# PLANNING AND ZONING COMMISSION MEMORANDUM

**FROM:** Planning & Zoning Department **DATE:** December 19, 2019  
**SUBJECT:** PP 2019-07 Consideration of a request from MM City Point 53 LLC for a preliminary plat of City Point Addition Phase 2, being 21.55 acres located at 4401 City Point Drive.  
**PRESENTER:** Clayton Comstock, Planning Director

FIGURE 1

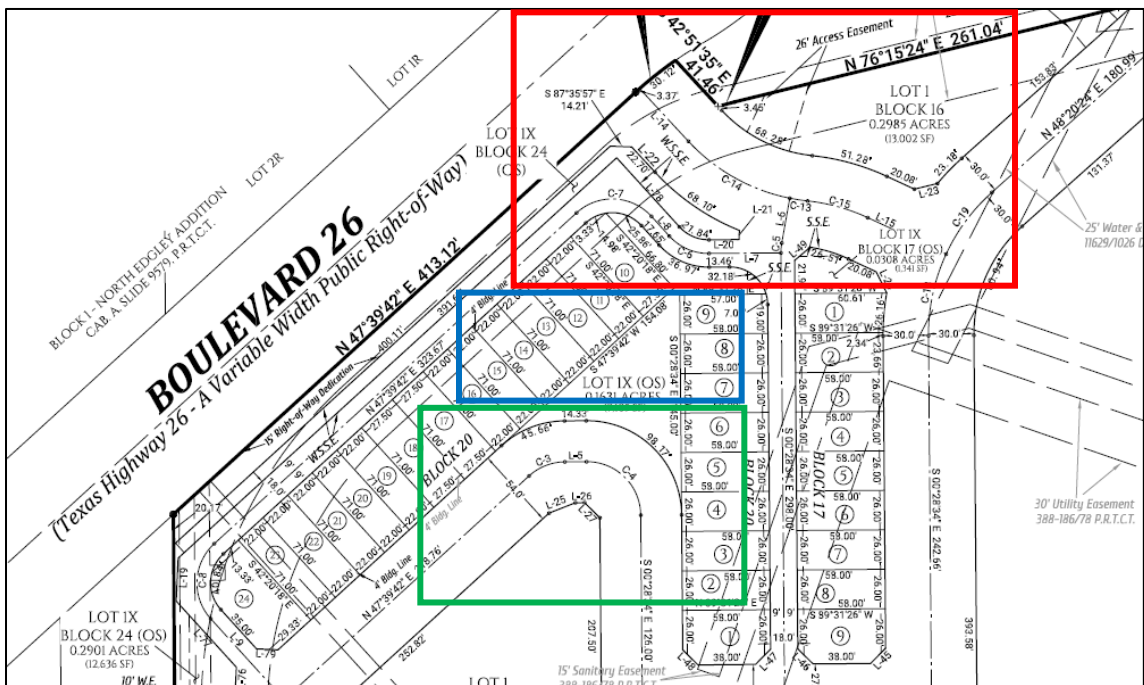
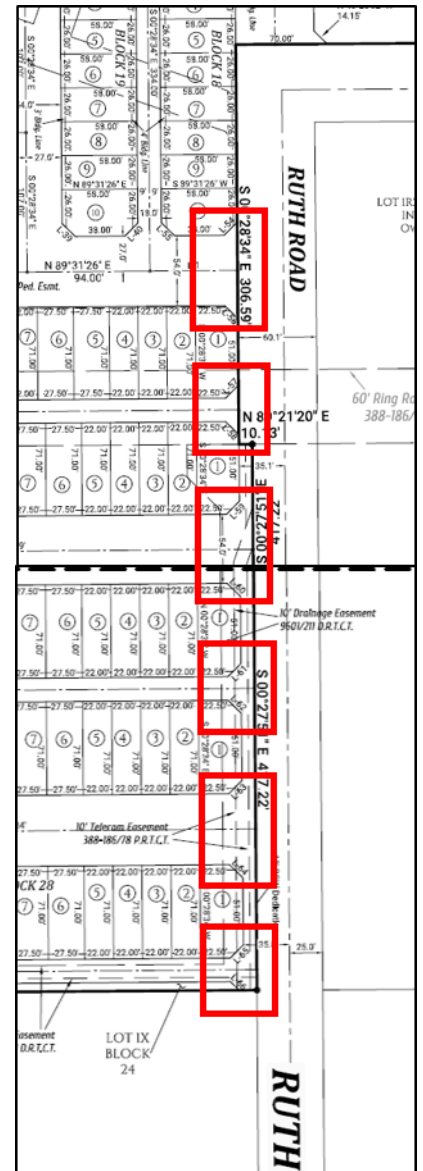
1. A new street entrance from Boulevard 26 is proposed south of the Japanese restaurant at the corner of City Point Drive. This new street is approximately 300 feet long and provides a connection from Boulevard 26 to the ring road around the development. At about the midpoint on this street, two alleys merge and intersect the new street (see red box in Figure 1 below). The configuration of this intersection poses several challenges related to traffic safety, engineering design, and emergency services.

The Development Review Committee has concerns about this confluence of multiple streets and alleys within such close proximity to Boulevard 26. This alignment could prove problematic if vehicles, including waste collection trucks, cannot maneuver safely through the acute angles of this intersection.

2. The design of the street connection also results in 11 lots fronting an open space lot. Since these lots do not have frontage on a public street, the delivery of emergency services to the lots becomes complicated. Utilities such as water and sewer would be located in the small area of the acute angled open space making it difficult for public works to access this infrastructure and significantly limiting any tree planting opportunities within the open space (see blue box in Figure 1).

3. The acute angle in the proposed street at the north end of the open space may be too tight for emergency service vehicles and may require revision as the project is further engineered (see green box in Figure 1).
4. While the proposed preliminary plat is reflective of the concept plan approved as part of planned development zoning, it was clear that the concept plan was also illustrative and not binding. All exhibits approved by the PD state, “the alignments, park/open spaces and trails are illustrative in nature and may change due to final surveys, field conditions, and environmental findings, utilities, final site plans, and City of North Richland Hills and other governmental agency reviews and approvals.”

The Development Review Committee recommends the applicant reevaluate the alignment of streets and blocks on the southern portion of this plat to orient homes toward Ruth Road for street activation, pedestrian orientation, and better internal access to open space.
